State of Ohio Environmental Protection Agency

Re: Storm Water Inspection at Kenyon Square II/Permit #4GC02948*AG

Figure 1

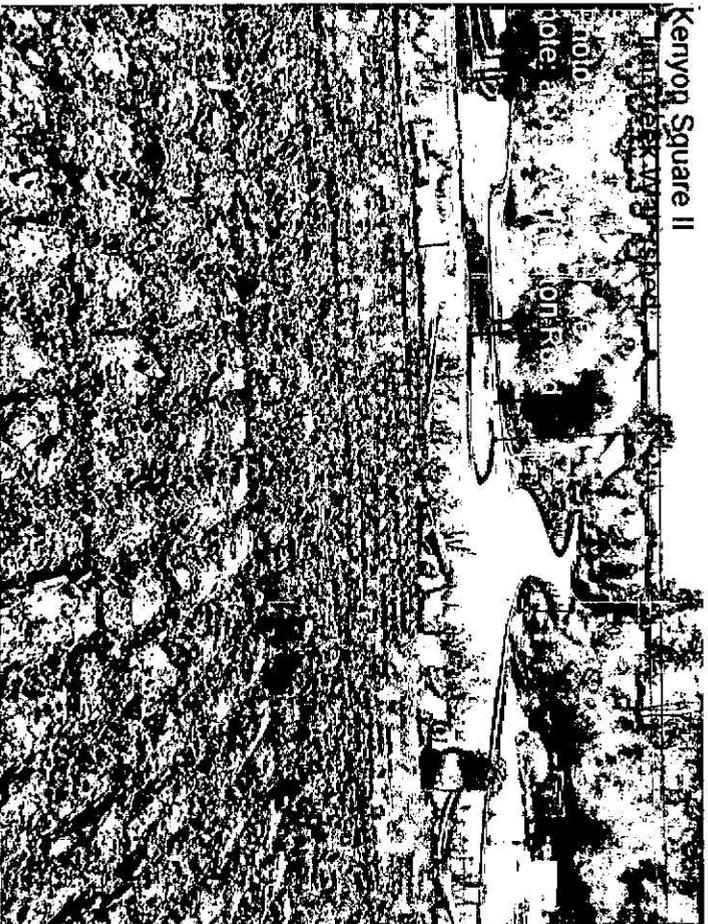
- The sediment fence along Worthington Road requires repair (See Photo Figure 1).
- Be aware the General Permit states that all barren areas which remain idle in excess of 21 days must be protected from erosion within seven days of the last earth disturbing activities. In addition, erosion protection must be implemented for all areas of final grade within seven (7) days.
